Please find attached two pdf documents outlining comments and questions for the Mesaba Energy Project draft EIS.

PUC Docket E6472/GS-06-668
DOE Draft EIS for the Mesaba Energy Project (DOE/EIS-0382D)
Comments on Draft EIS

5.2.4.1 West Range – Water Resources

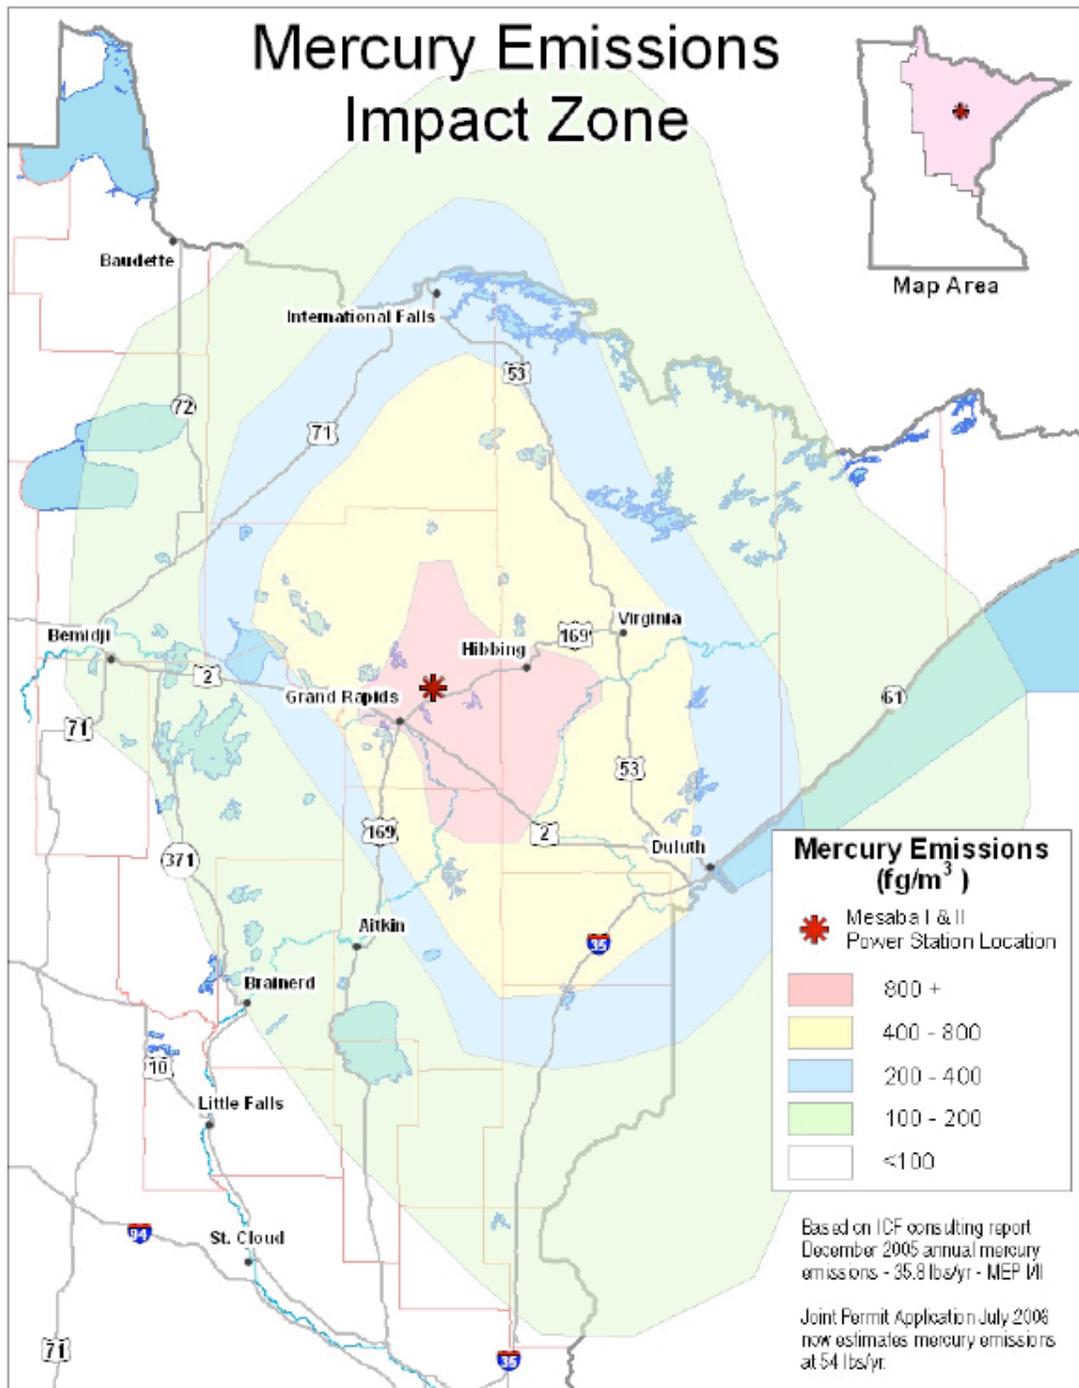
It is false to say that the MEP wouldn't add any mercury to water discharges. Air emissions also have an affect on water quality. The JPA mentions Phases I & II of the MEP as emitting 54 lbs of mercury annually, with highest concentrations closest to the location of the proposed plants, (see Mercury Emissions Impact Zone below).

These emissions will greatly impact all of our water resources with those nearest becoming contaminated faster and more concentrated than they are currently. The 720 lakes identified in the Mercury Deposit Zone all need to be

tested for current levels of mercury to determine if they would be at risk to additional levels of mercury deposition. This should include MSI emissions from the operational plant and whatever power source is agree upon and built by Nashwauk PUC.
